© 2014 Mazda Motor of America, Inc.

Subject: REAR CONSOLE LID IS LOOSE	Bulletin No: 09-045/14
	Last Issued: 11/24/2014

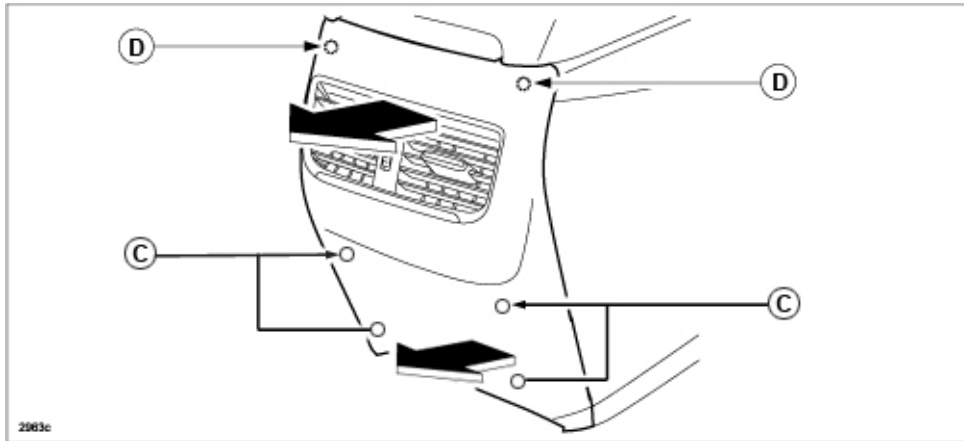
Some customers may complain about a loose rear console lid (A).

This may be caused by hinge pins coming partially off (B) or completely off.

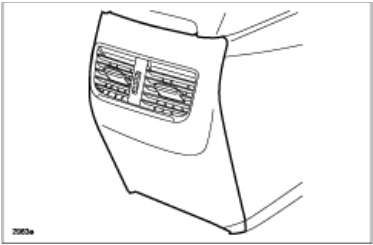
1. Verify customer concern.
2. Remove the rear console panel by pulling in the direction of the arrows shown below.

NOTE: Begin by pulling from the bottom to detach inner attachment clips (C), then continue pulling from the top to detach inner attachment clips (D).

3. Re-install the rear console lid pin(s) back to the original position.

4. Install a new rear console panel. (See PART(S) INFORMATION)

NOTE: The shape of the rear console panel has been changed, by adding a stopper rib to prevent the pin from coming off.
